Title: Cavalon 915 Lower Engine Cowling Heat Protection		
AG-SB-2020-05-B-EN		Compliance Category:
Applicability		
Aircraft type & model: AutoGyro Cavalon	Affected Serial number(s): All Cavalon fitted with the Rotax 915iS engine	A – MANDATORY B – RECOMMENDED C – OPTIONAL
The maintenance manual to be referenced is this stated or subsequent issue.		As per AutoGyro website
This form is the response from AutoGyro GmbH either against a problem found in the product in service requiring a containment or rectification action, or as service information for aircraft modification incorporation. For help, contact AutoGyro on 49(0)5121 88056-00, or email airworthiness@auto-gyro.com .

(Pic. 1)

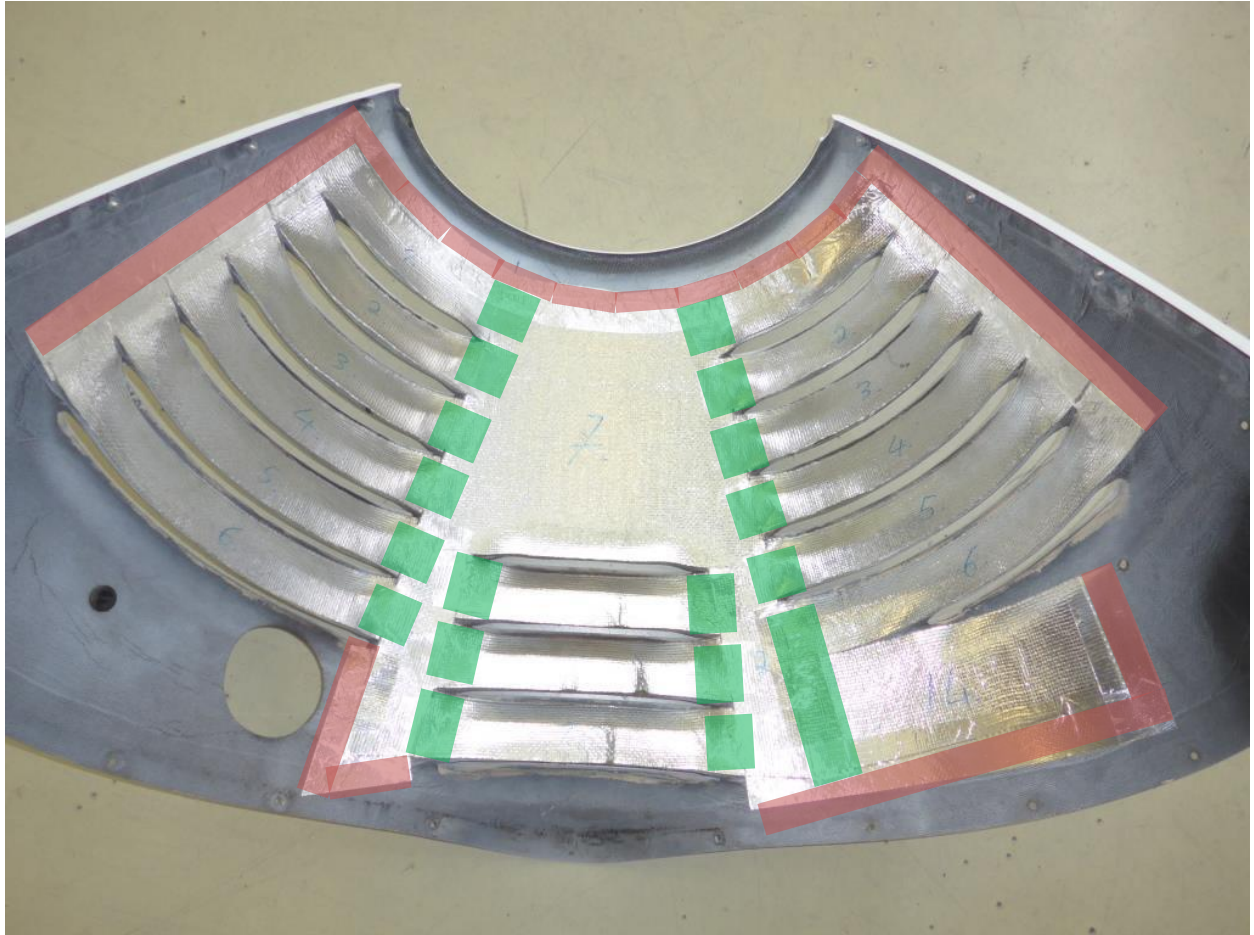
3. De-grease the inside area of the lower engine cowling in the areas where the heat protection is to be applied.
4. Attach the heat protection to the lower engine cowling using Pic. 1 below as a guide.
